WEG-NGTL-001

Non-Direct Costs

WEG-NGTL-002

Diagram Alternative COH 1 Illustrative Rate Calculation

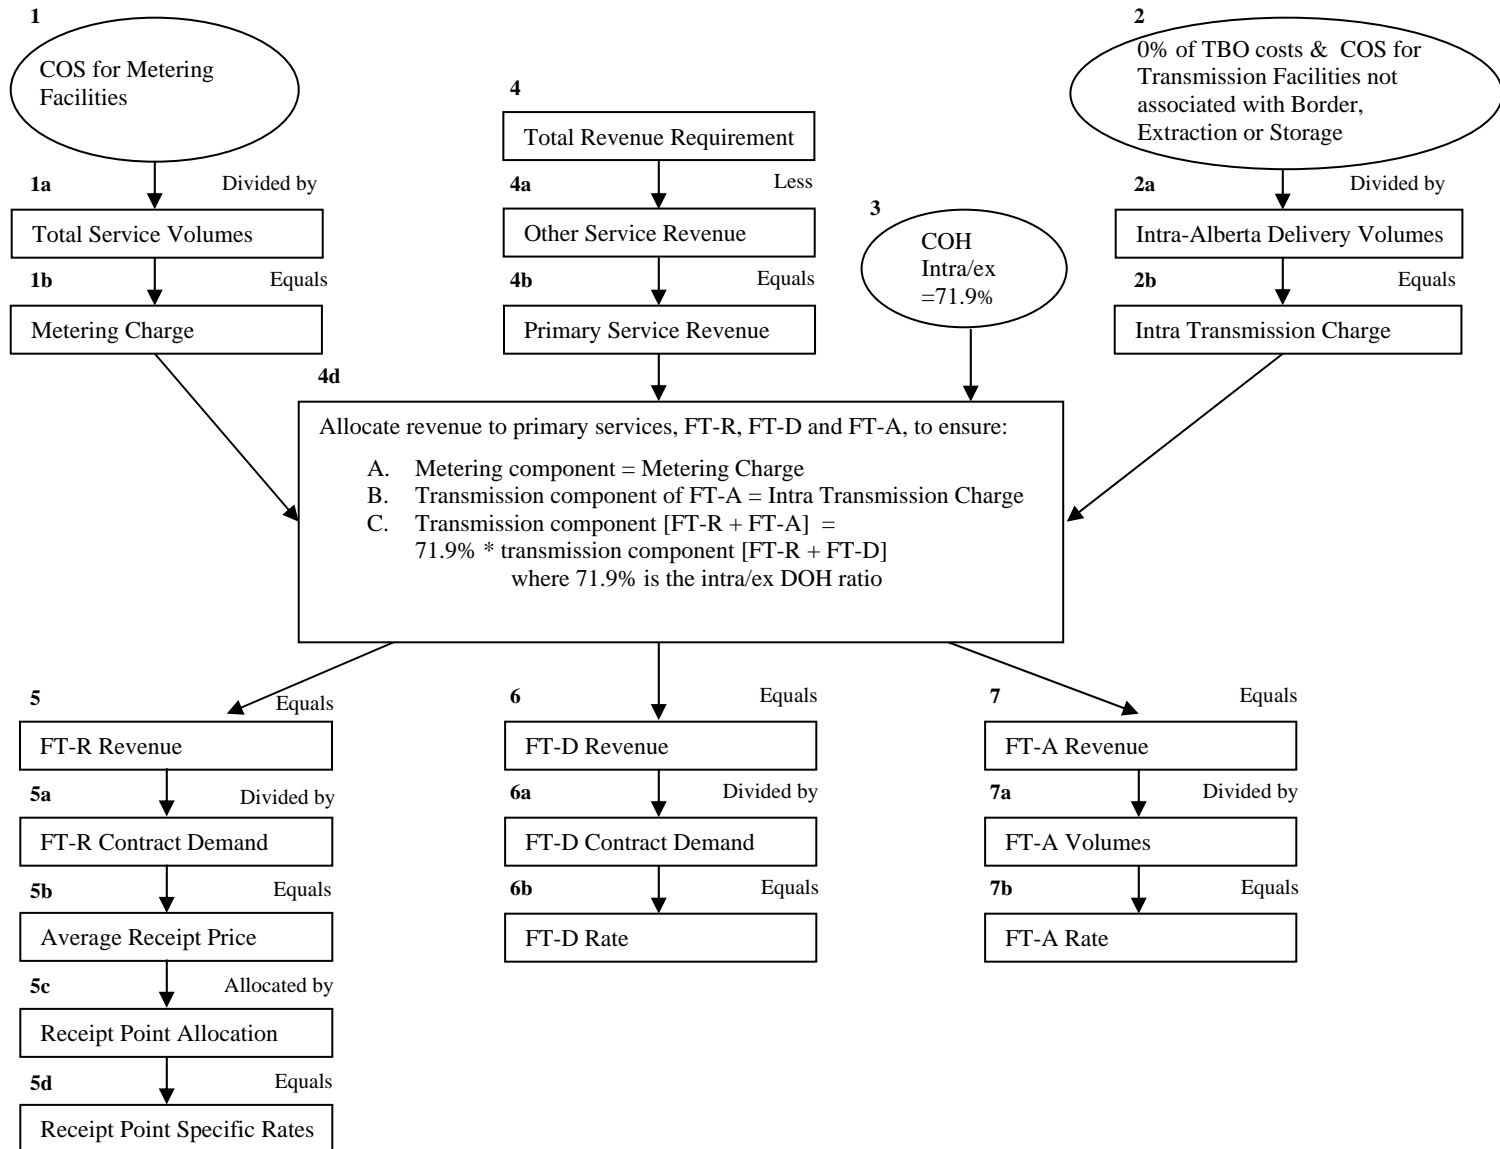
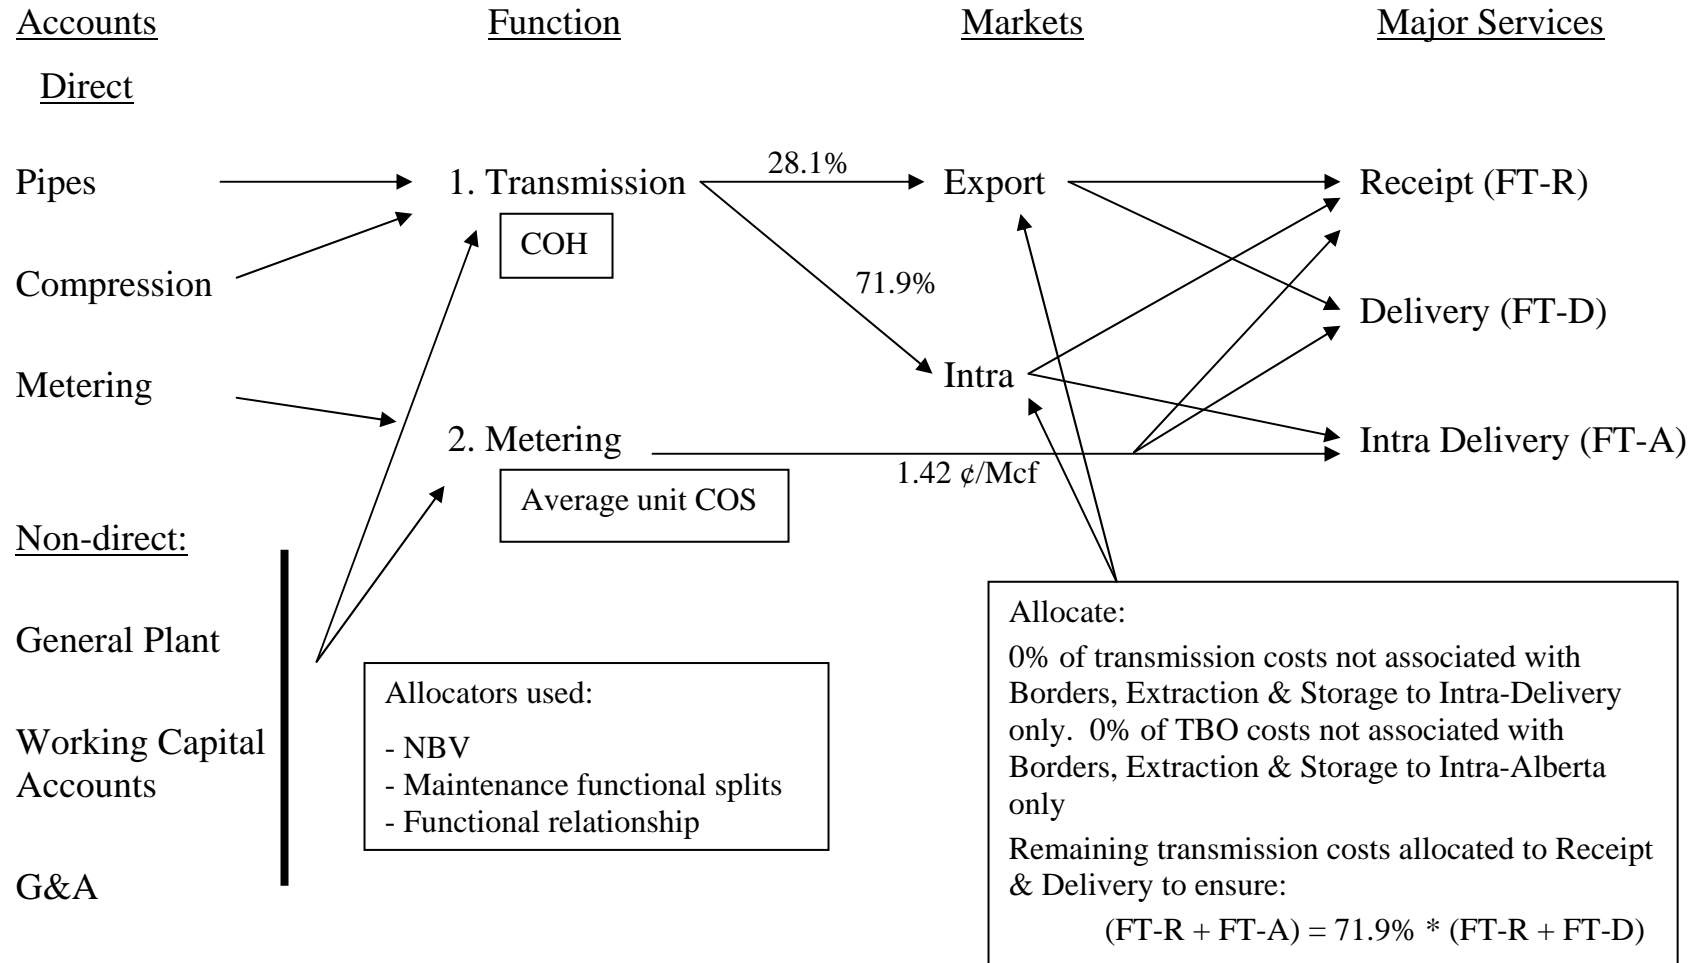
- (a) For the most recent COS, please recalculate, based on COH instead of DOH, the following:
 - (i) Table 2.2.2-1 Comparison of Alternatives 1 to 3,
 - (ii) Table 2.2.2-3 Illustrative Rates and Ratios from Application of Existing and Alternative COS Methodologies,
 - (iii) Table 2.2.2-4 Change in Existing Illustrative Rates and Ratios from Application of Alternative COS Methodologies, and
 - (iv) Table 2.2.2-5 Change in Existing Illustrative Rates and Ratios from Application of Alternative COS Methodologies.
- (b) If not provided in response to (a) above, please provide the FTR, FTA and FTD rates if they were to be derived utilizing a COH-based cost split rather than a DOH-based cost split. Show the calculations and indicate all assumptions made in arriving at these rates.

- (a) Please refer to Attachment WEG-NGTL-012(a).
- (b) Please refer to Attachments 1 through 3, WEG-NGTL-012(b) for all calculations and assumptions.

Box/Oval	Diagram Alternative COH 1
Oval 1	\$114,741,982
Box 1a	22,137,781 Mcf/d
Box 1b	\$0.0142 Mcf/d
Oval 2	\$0.0 million
Box 2a	513.7 Bcf/yr
Box 2b	\$0.00 Mcf/d
Oval 3	Intra/Ex COH 71.9%
Box 4	\$1,160 million
Box 4a	\$314.9 million
Box 4b	\$845.0 million
Box 4d	n/a
Box 5	\$604.6 million
Box 5a	2,920.1 Bcf/yr
Box 5b	\$0.2070 Mcf/d
Box 6	\$240.4 million
Box 6a	2,684.7 Bcf/yr
Box 6b	\$0.0896 Mcf/d
Box 7	\$5.3 million
Box 7a	374.71 Bcf/yr
Box 7b	\$0.0142 Mcf/d
